RE: 204-210 Parramatta Road, Auburn, NSW 2144 – Facts and Contentions

In response to the Statement of Facts and Contentions (case no: 2022/00175835) raised by Cumberland City Council, Meinhardt Group has been engaged by Skematics to address all stormwater contentions identified in Part B – Contentions. The stormwater contentions raised by Council have been outlined below with responses provide by Meinhardt Group.

DESIGNED	DRAWN	APPROVED	DATE	SCALE @A1	SHEET
JD	SY	LM	28.11.19	1:100	OF
PROJECT No		DRAWING No		REV	
121465		C101		P04

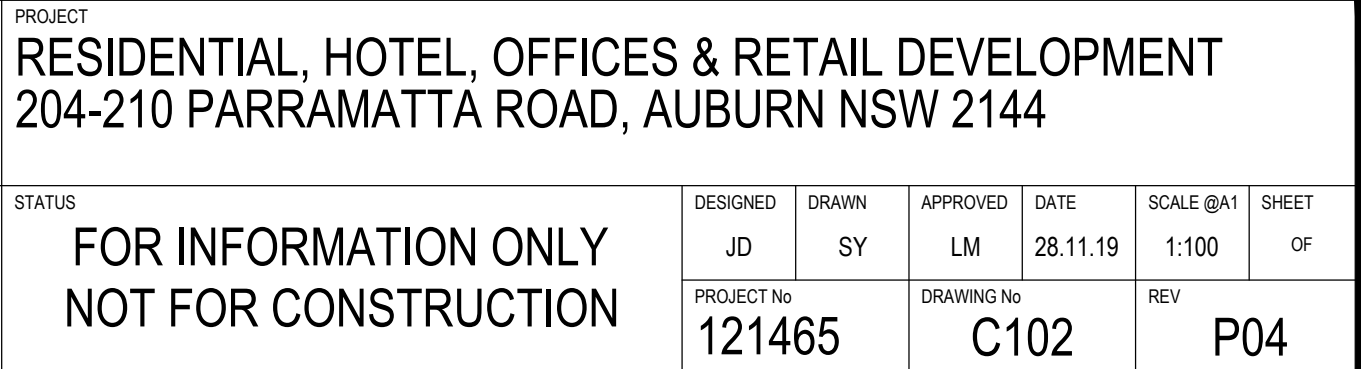
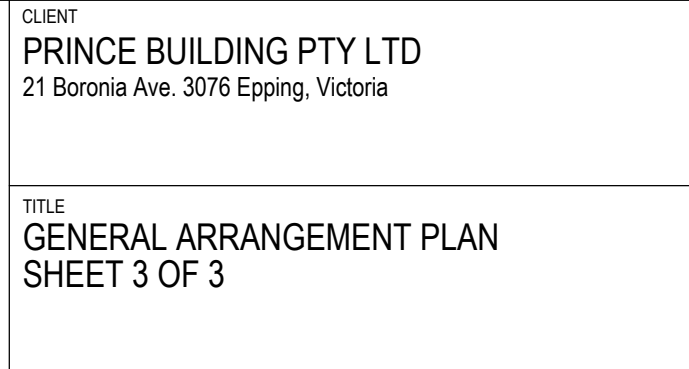
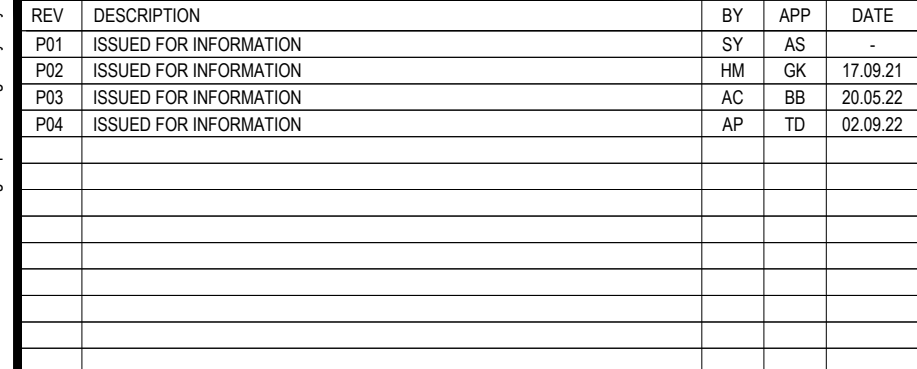
- (a) The development has not made provision for the stormwater pipeline extension underneath the kerb and gutter. The proposed stormwater drainage works on the public road reserve at Braemar Avenue would interfere with all existing services and neighbours’ driveways.

The pedestrian footpath and grated inlet pits have been identified on survey plans and shown on drawing sheet C100 and C101. The survey additionally identified an existing dish drain on the pedestrian crossing as shown on drawing sheet C101.

The stormwater drainage network proposed on Braemar Avenue (refer to drawing sheet C100, C101, & C102) has been located underneath the kerb and gutter. The proposed stormwater drainage network will not impact existing services located in Braemar Avenue verge or existing property driveways. Additional kerb inlet pits have been proposed to collect surface runoff in Braemar Avenue. The proposed stormwater drainage network will improve the existing stormwater drainage infrastructure in Braemar Avenue.

The proposed drainage network will connect to an existing stormwater pit (ID 5/15SP018506) located adjacent to the roundabout in Braemar Avenue. The existing stormwater pit is in the verge immediately downstream of an existing crossover which provides access to 12 Braemar Avenue, Auburn. Minor construction works of the layback and vehicle crossing will be required to install the proposed stormwater drainage network to the existing Council pit. Construction works should be undertaken to limit the inconvenience imposed to the resident of the property.

PROJECT RESIDENTIAL, HOTEL, OFFICES & RETAIL DEVELOPMENT 204-210 PARRAMATTA ROAD, AUBURN NSW 2144	STATUS FOR INFORMATION ONLY NOT FOR CONSTRUCTION	DESIGNED JD	DRAWN SY	APPROVED LM	DATE 22.01.20	SCALE @A1	SHEET OF
PROJECT No 121465	DRAWING No C210	REV P06

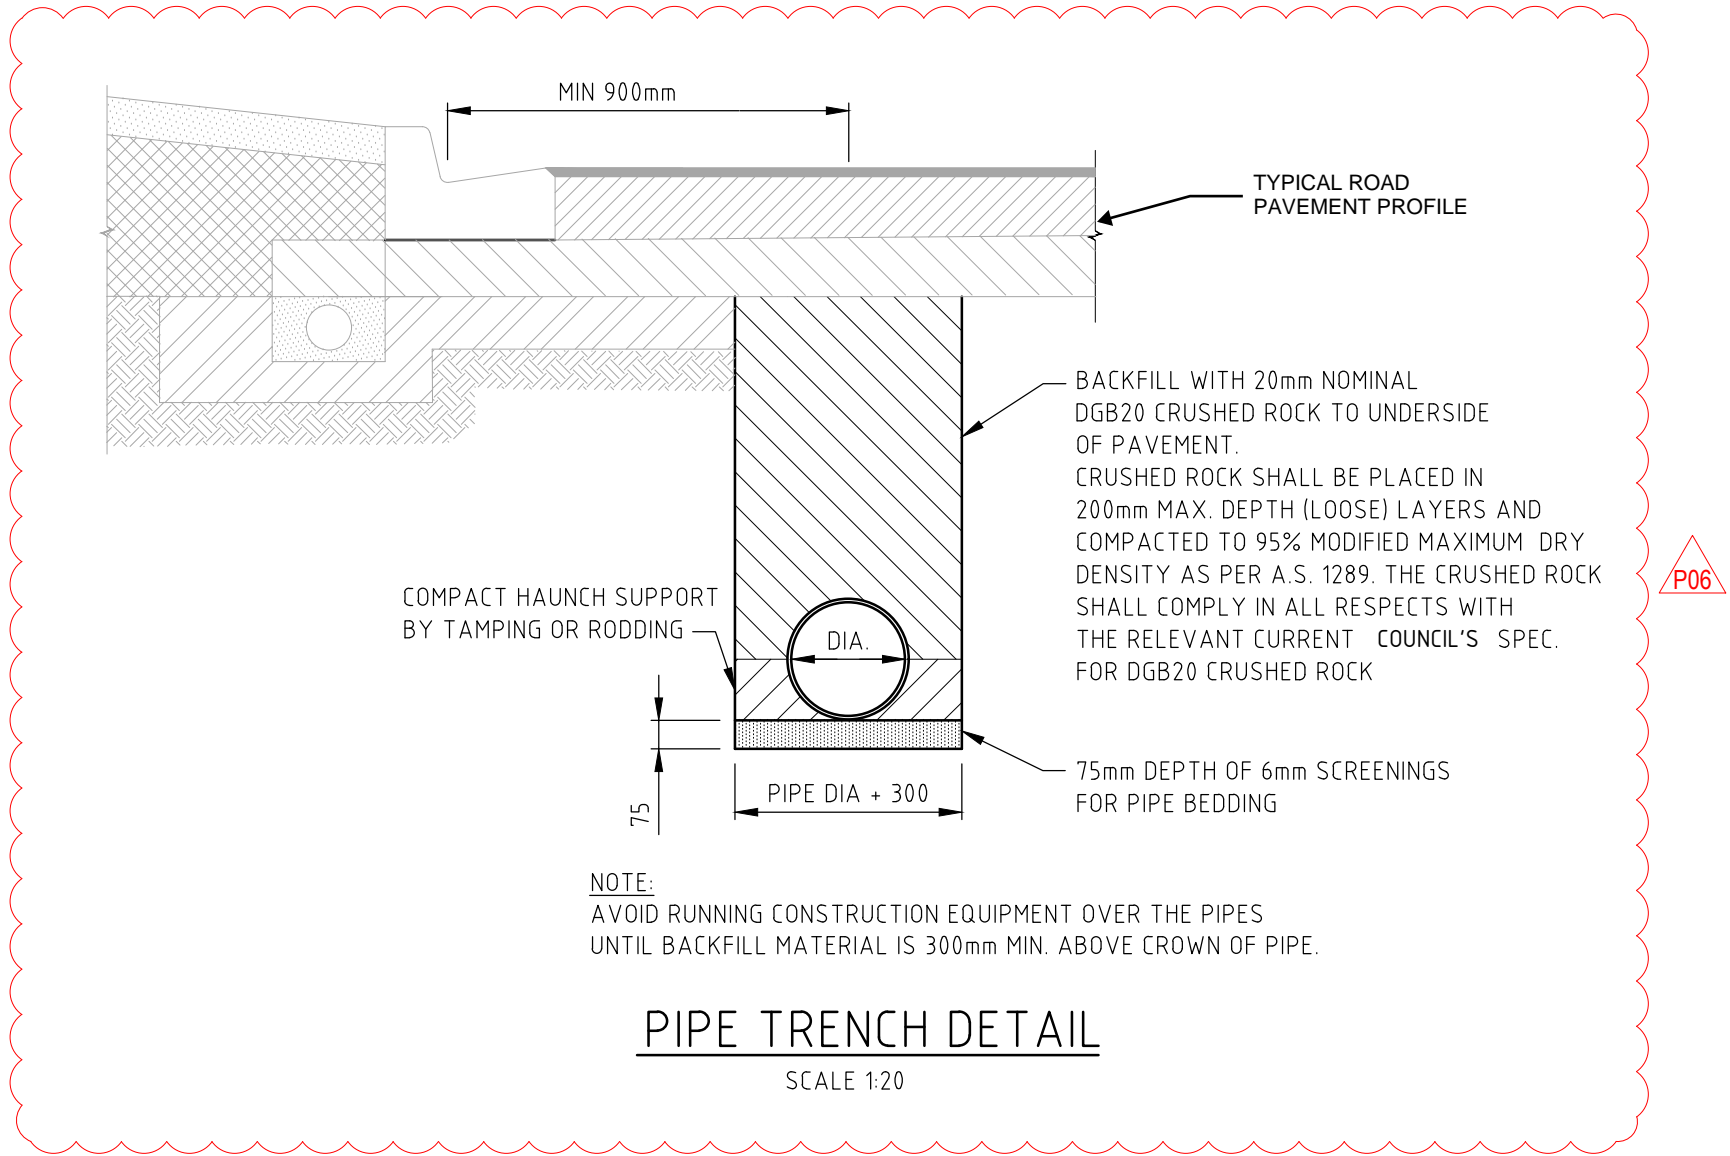
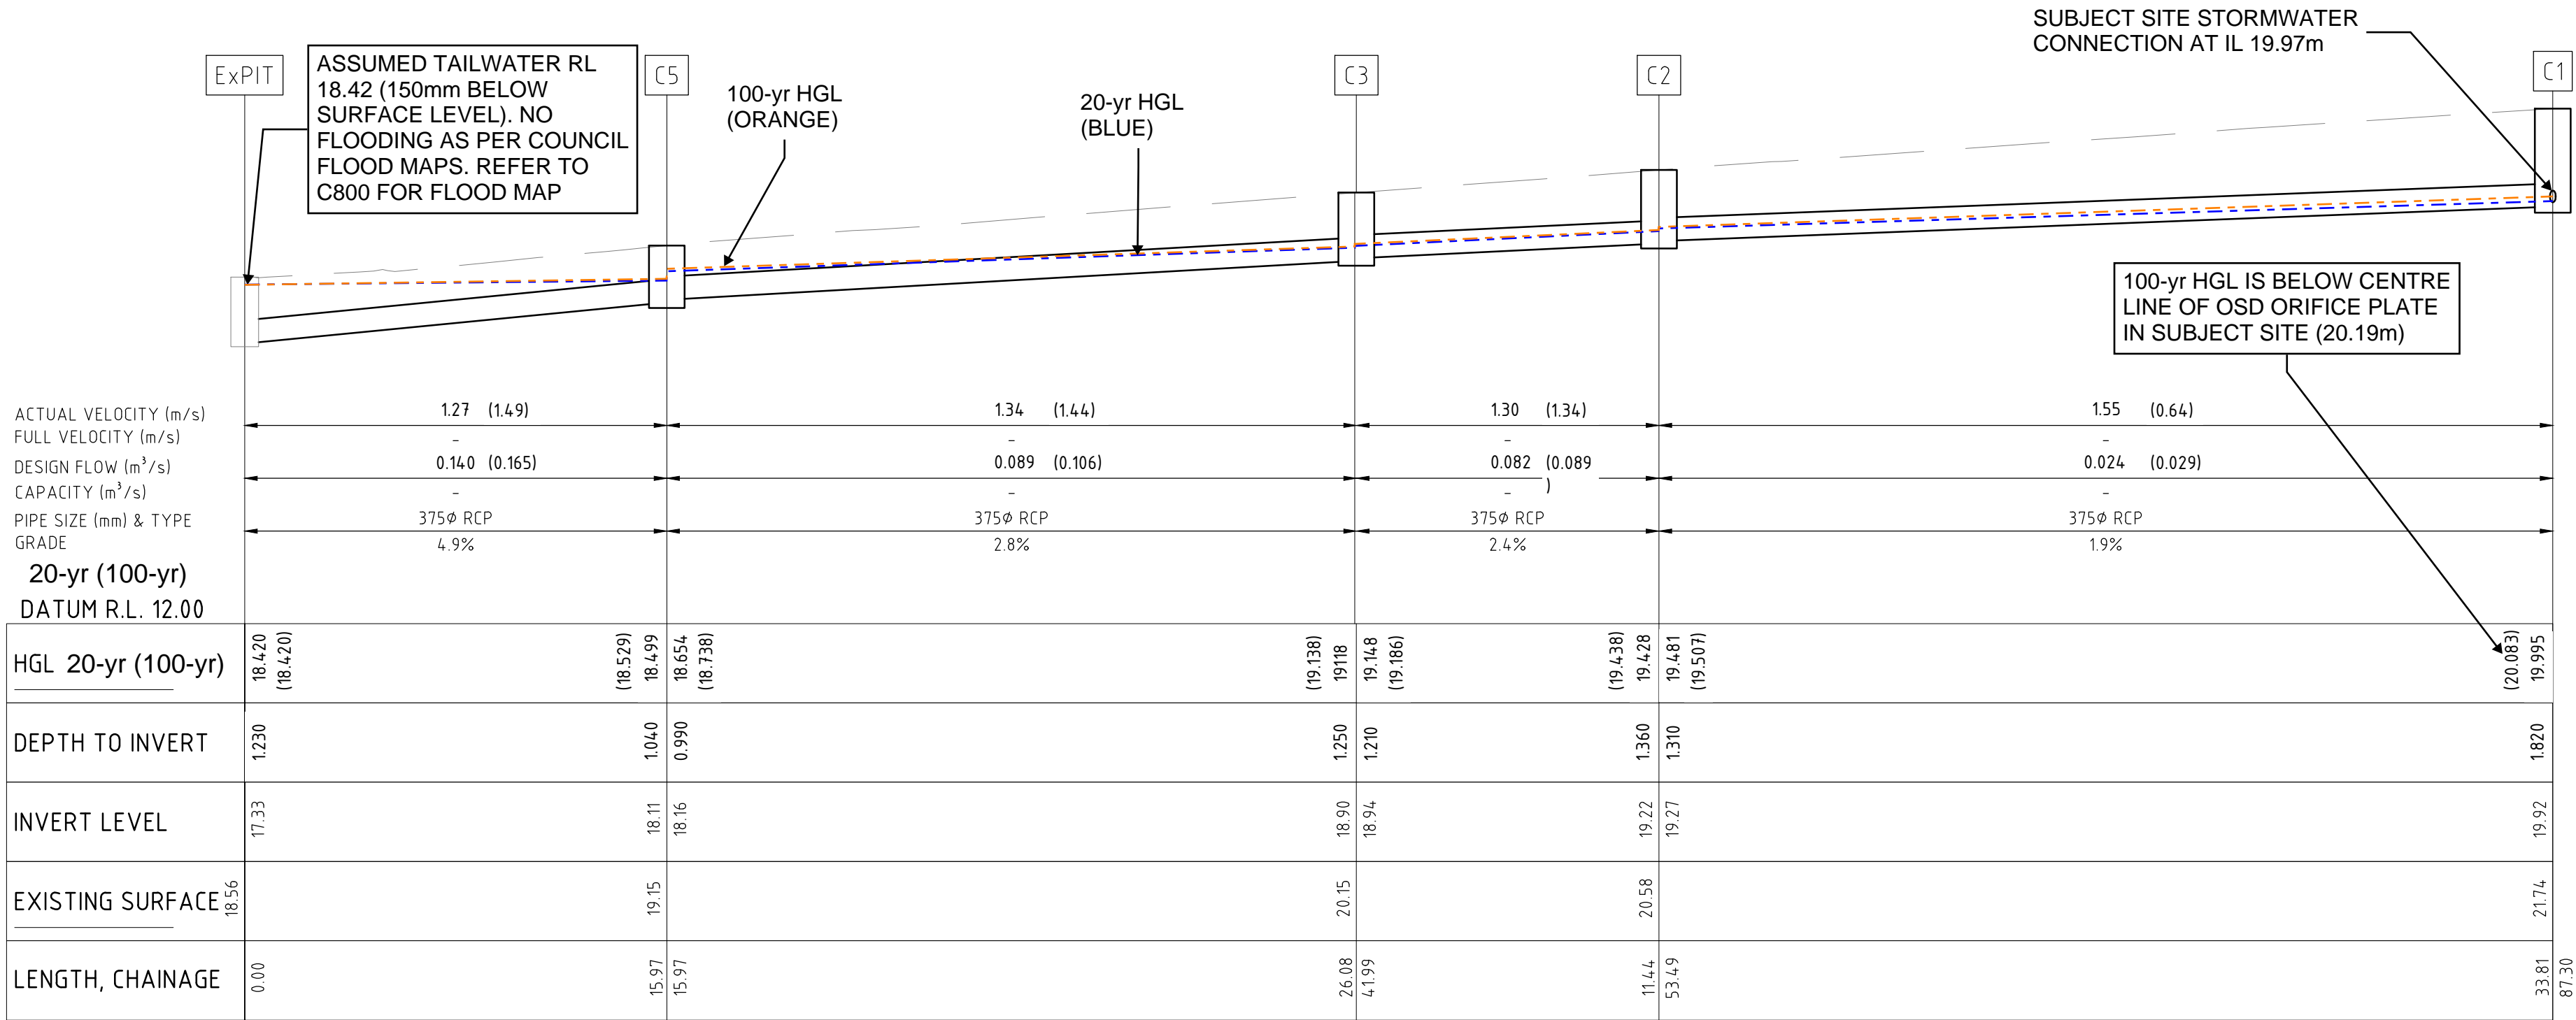
- (b) Fully detailed designs, including a long section of the pipe, a pipe trench cross-section detail and connection point into Council's drainage system, have not been submitted for all proposed drainage works within the road reserve. All the design details should be provided, including hydraulic grade lines based on the 5% and 1% AEP storms.

Refer to drawing sheet C210 for stormwater drainage long section, pipe trench cross-section detail. Refer to drawing sheet C102 for connection point into Council's drainage system. Refer to longitudinal section of the proposed stormwater drainage network for the hydraulic grade lines based on 5% and 1% AEP storms.
